CITY OF OREGON CITY HISTORIC REVIEW BOARD AGENDA

Virtual Meeting
Tuesday, March 02, 2021 at 7:00 PM

1. GLUA-21-00007/ HR 21-00006: Historic Review for alterations to the Ely Store at 1019 7th Street
2. GLUA-21-00001/ HR 21-00001 through 21-00005: Historic Review for Canemah Cottages in the Canemah National Register Historic District.
3. New HRB Policy for Murals in Historic Overlay

GLUA-21-00007/ HR 21-00006: Historic Review for exterior alterations to the historic Ely Store, a designated structure in the McLoughlin Conservation District at 1019 7th Street.

ELY
STORE

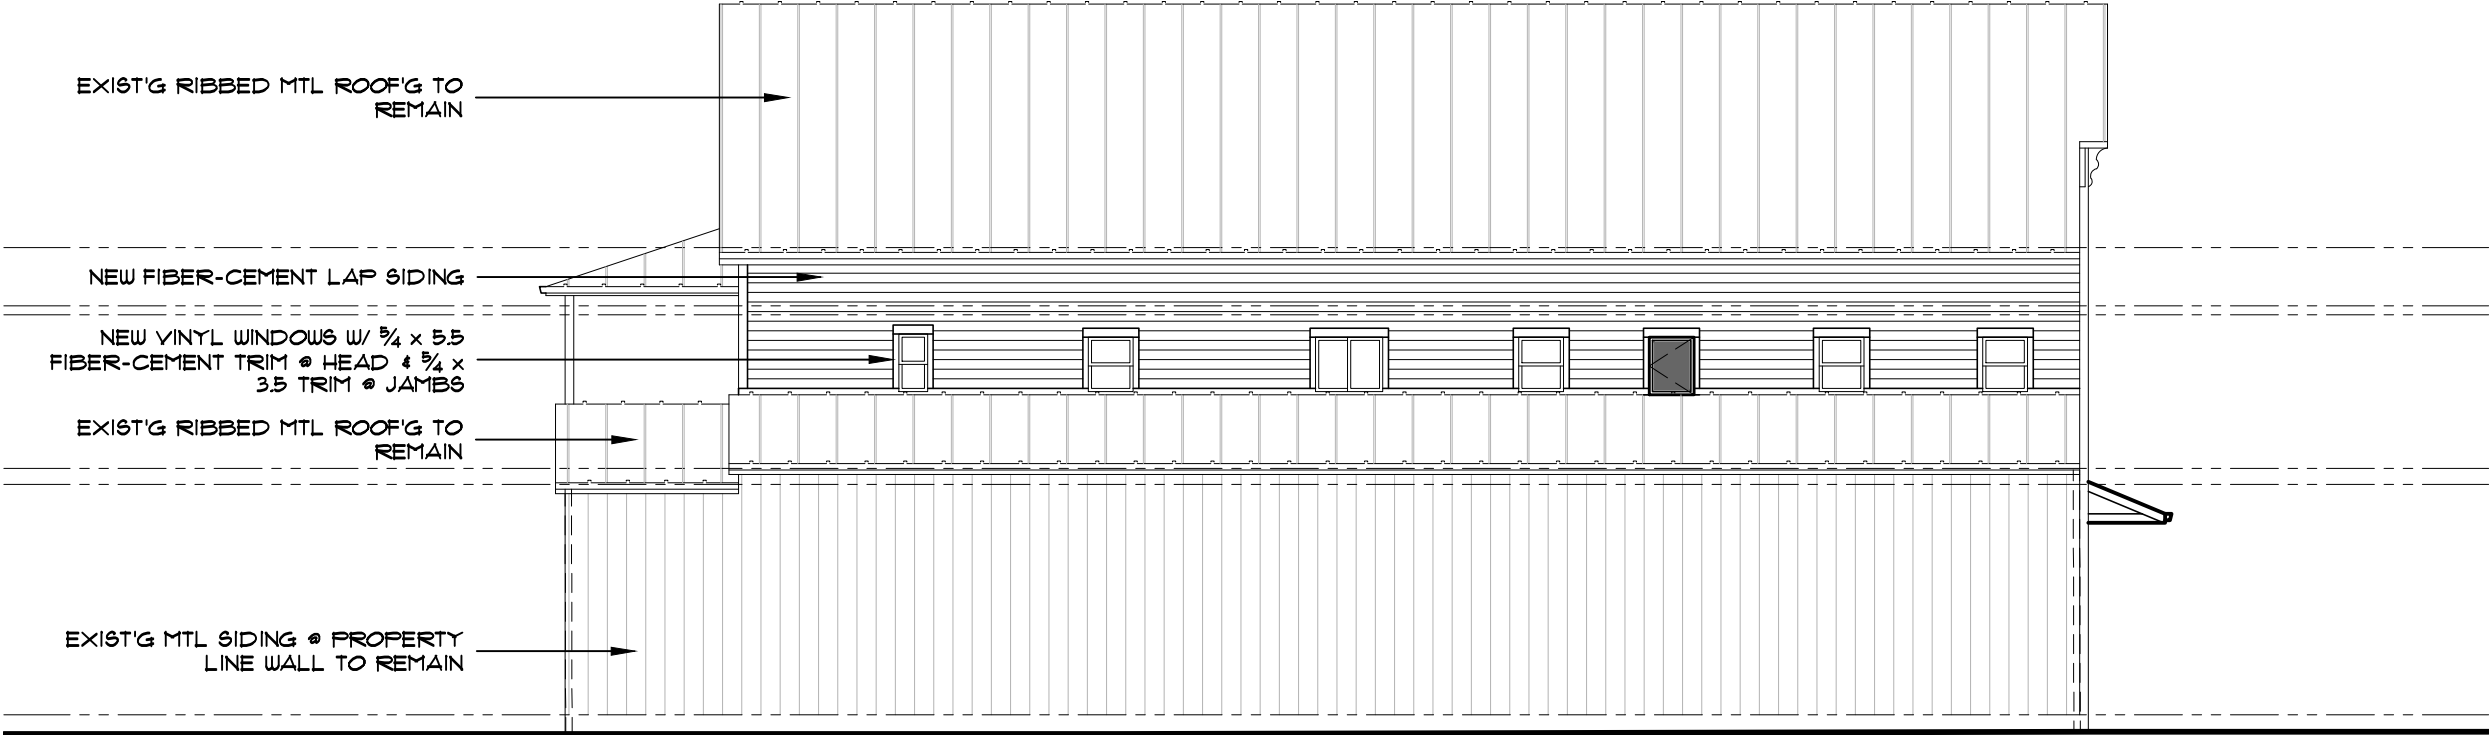
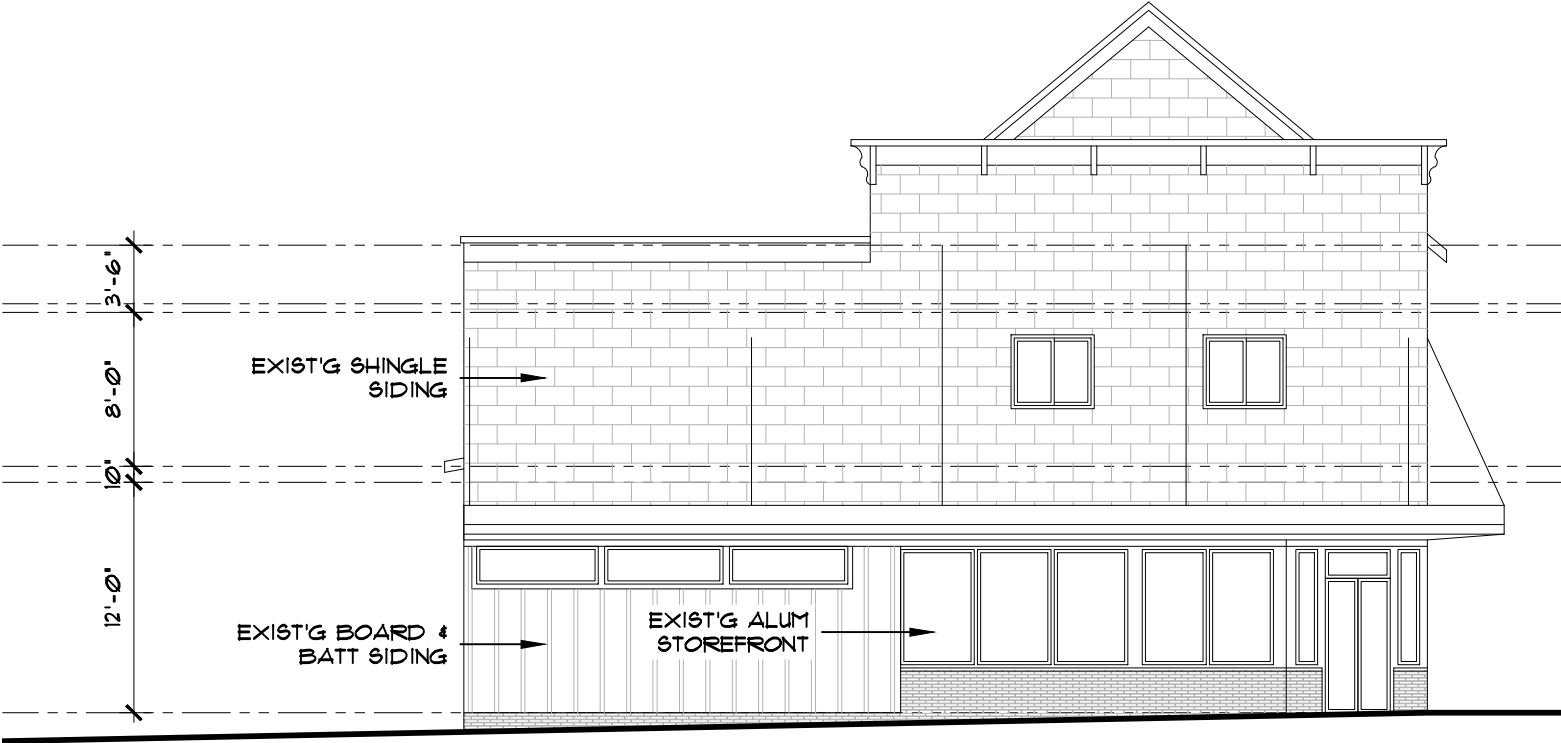
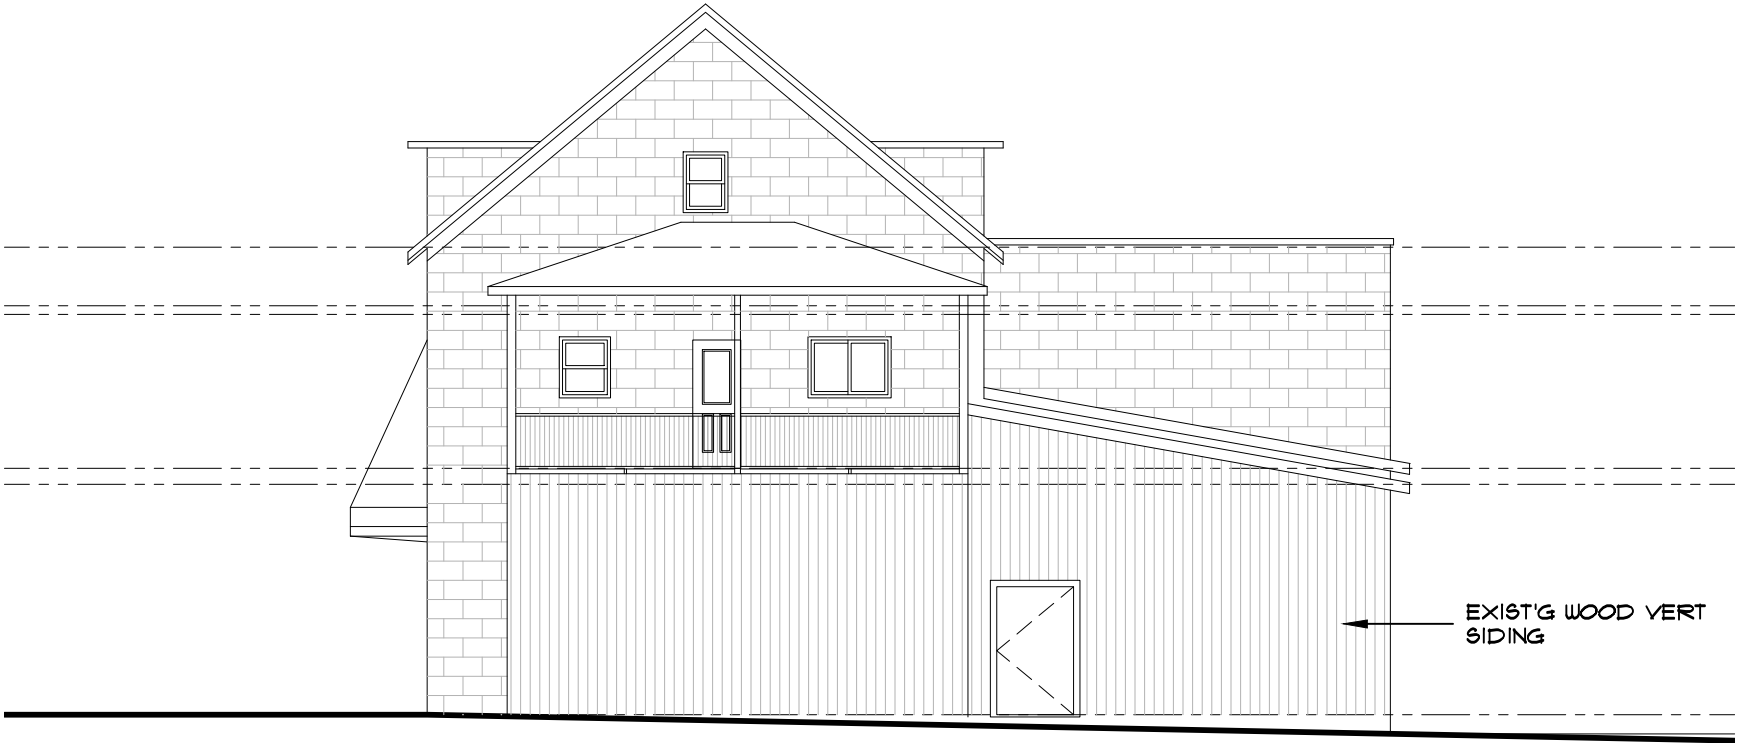
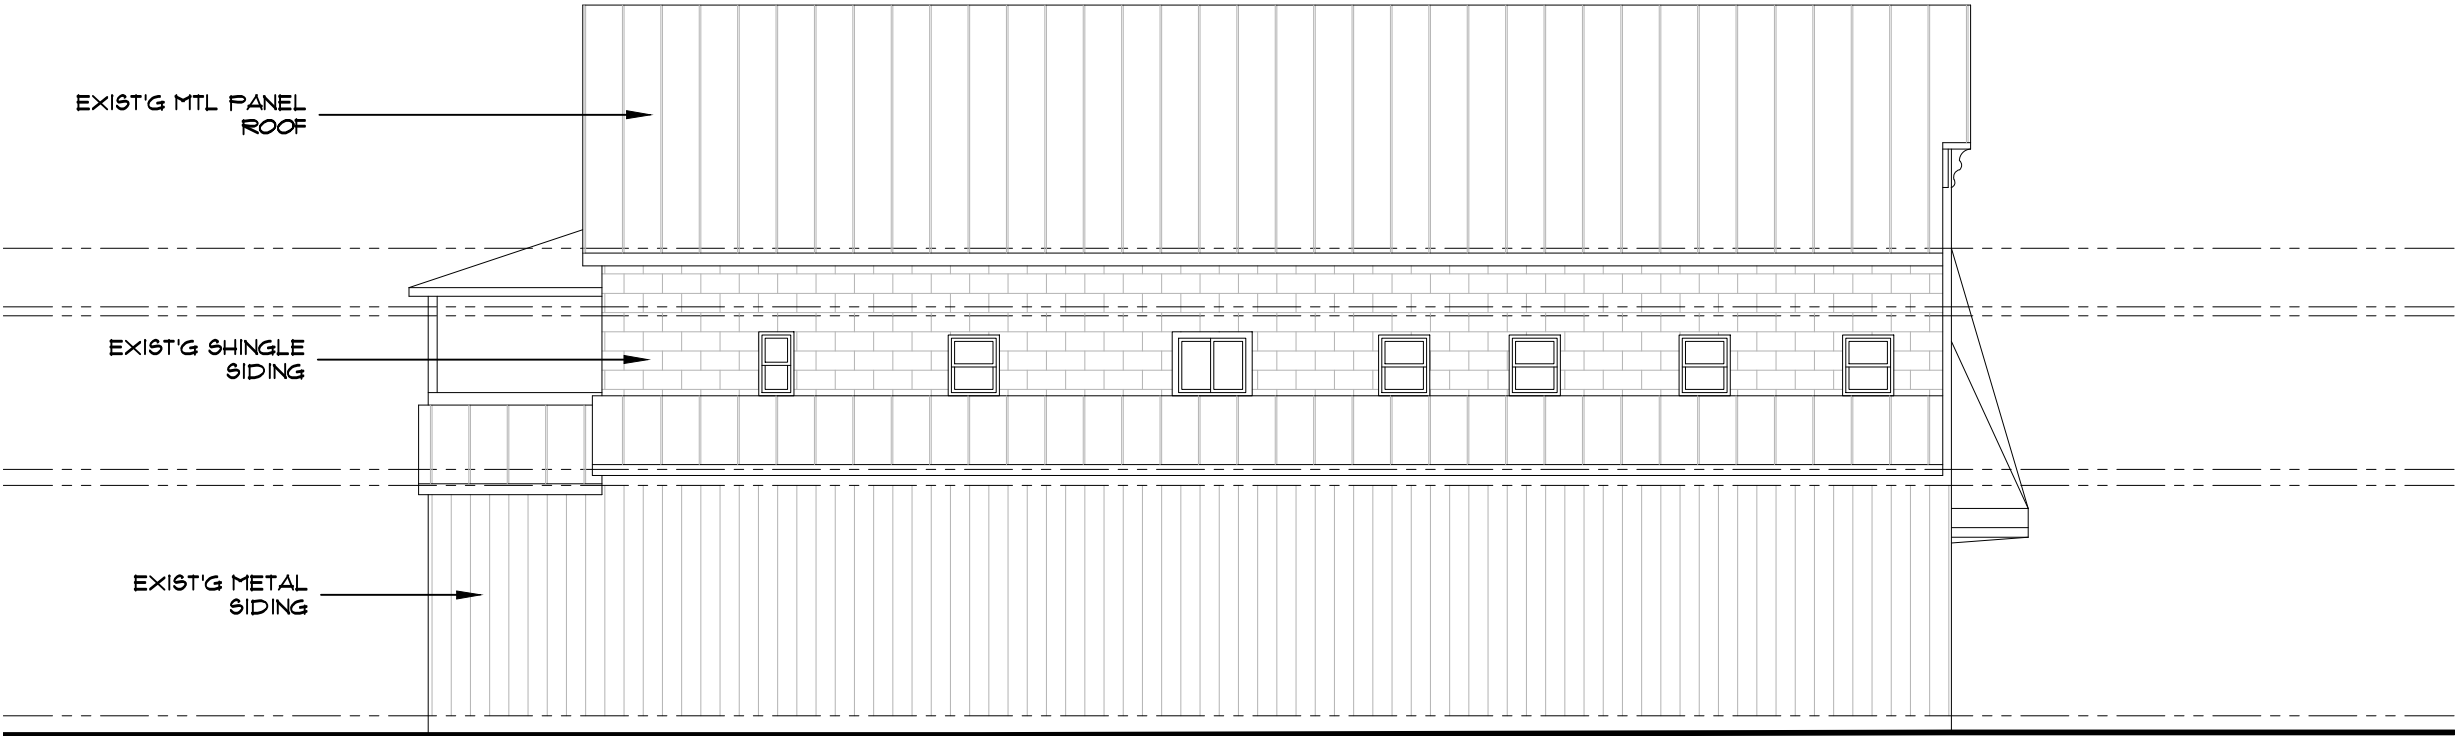
Staff cannot recommend approval of replacement of wood windows with vinyl windows. A condition of approval is recommended to repair the wood windows, potentially relocating them to the JQ Adams side façade if the sizes match the openings. The applicant shall document the condition of the wood windows and obtain a cost estimate for repair. The HRB should provide direction regarding the type of window that is acceptable as a replacement, if replacement is pursued.

Staff Finding: Complies as Proposed. The applicant’s proposed changes are consistent with the original building design, except for the awning design. The change in awning design is proposed to be more structurally sound. The length of the awning is proposed to extend around the corner to provide cover over the storefront windows on the JQ Adams façade. An additional awning is proposed over the third storefront entrance on JQ Adams. The additional entry on the JQ Adams side is not conjectural feature, rather, it is a modern update to provide an additional commercial space. Staff finds that these designs are compatible.

There is no good photographic evidence of the side elevations of the building and the windows have all been modified with different size openings. The applicant has proposed rectangular windows with some larger sizes for egress purposes. While it is likely that the side windows would have been the same as the windows on the front upper story, staff finds that the retention of the current window locations and sizes, with some variation to meet building codes, is acceptable and will not create a false sense of historical development.

While the applicant indicates willingness to salvage and retain materials, the statement “retained to the extent possible” is vague and does not provide assurance that the existing distinctive materials will actually be retained. If it is existing under the current siding, the applicant shall retain and restore the ornamental shingle siding on the upper front facade. The six brackets on the false front shall also be retained and restored.

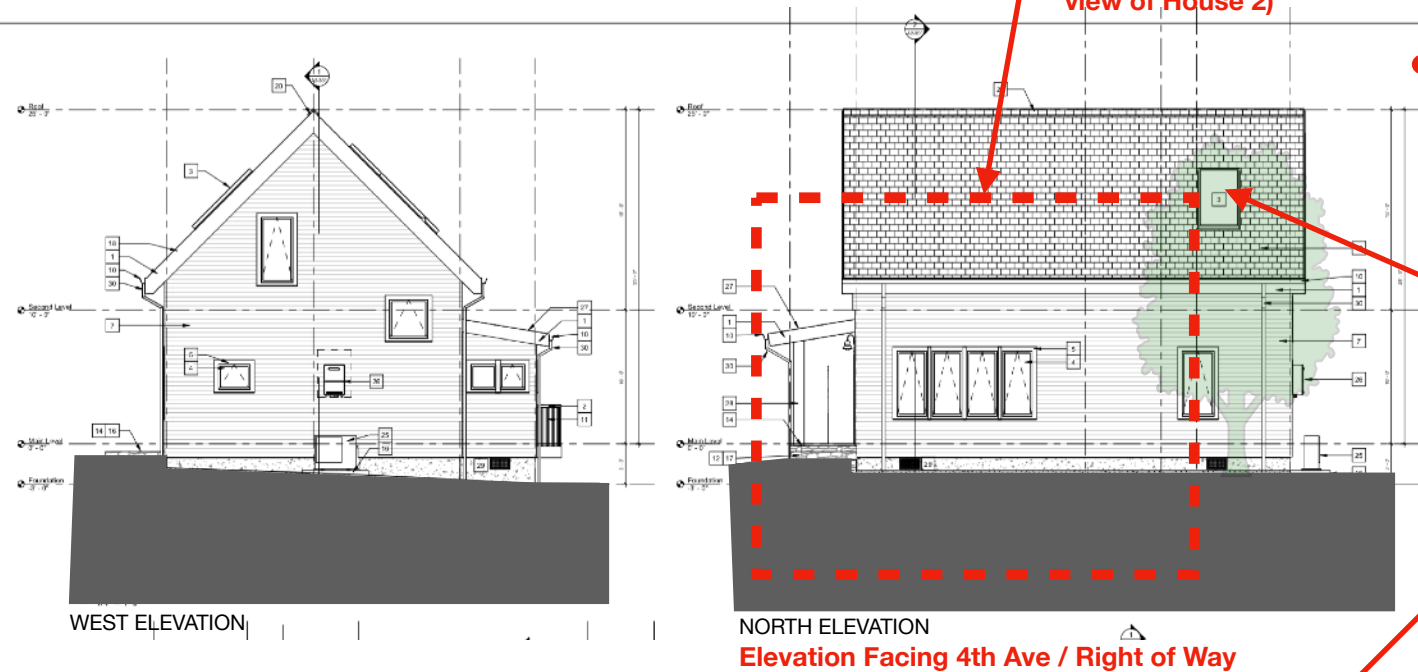
➔ Fascia width is the same on all homes, was not specified in original HRB application; there is no specific fascia width requirement in Canemah.

View of Skylight, facing 4th Ave ROW is mitigated by landscape; is flush with roof and inconspicuous.
